DAVID GRUEL
DECK 2
192354
3D View

PENN TOWNSHIP
Approved Construction Documents
Building Permit # 6512
[Signature]

DAVID GRUEL
DECK 2
192354
Deck Layout

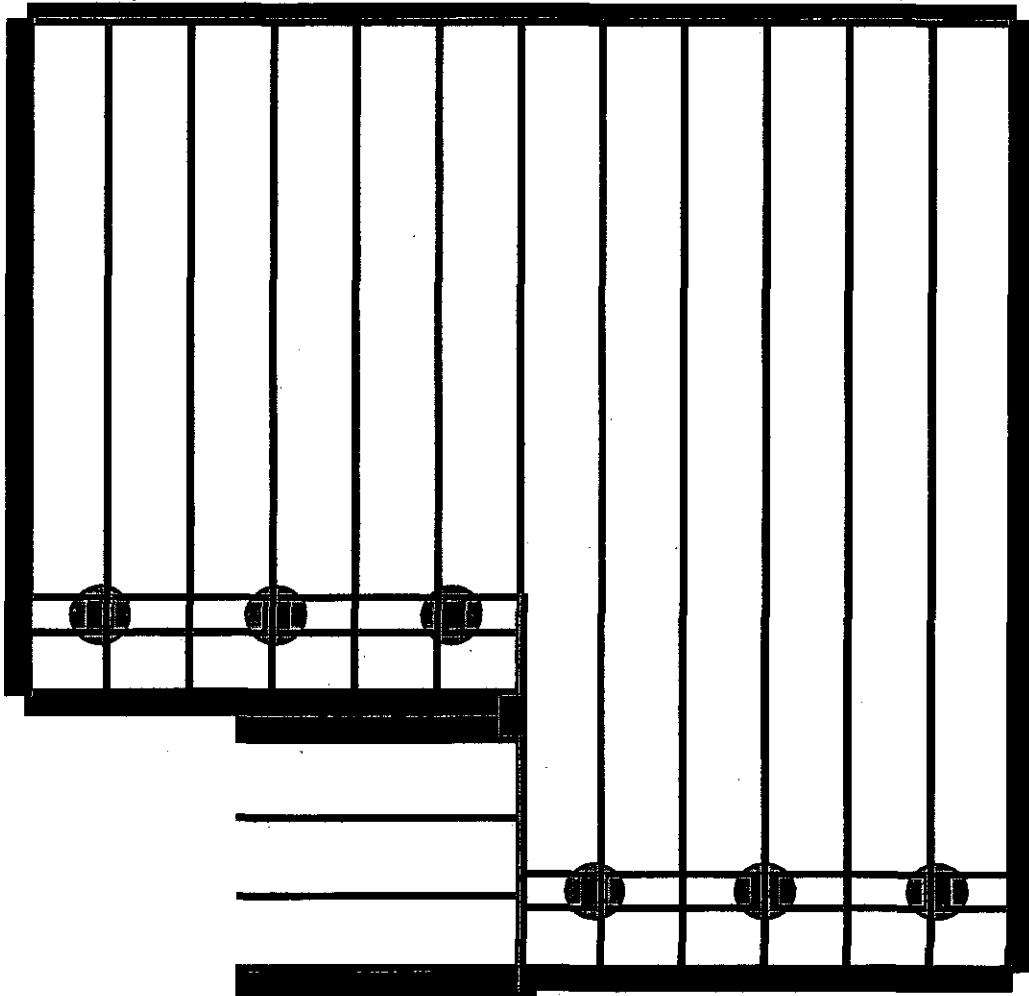
Concealed flange joist hangers @ corners

Joist hangers required

All fasteners shall be corrosion resistant

See deck ledger table

Footers shall be 10" min

Solid blocking between joists above beams

Assemble beams on notched post.

Stair footers
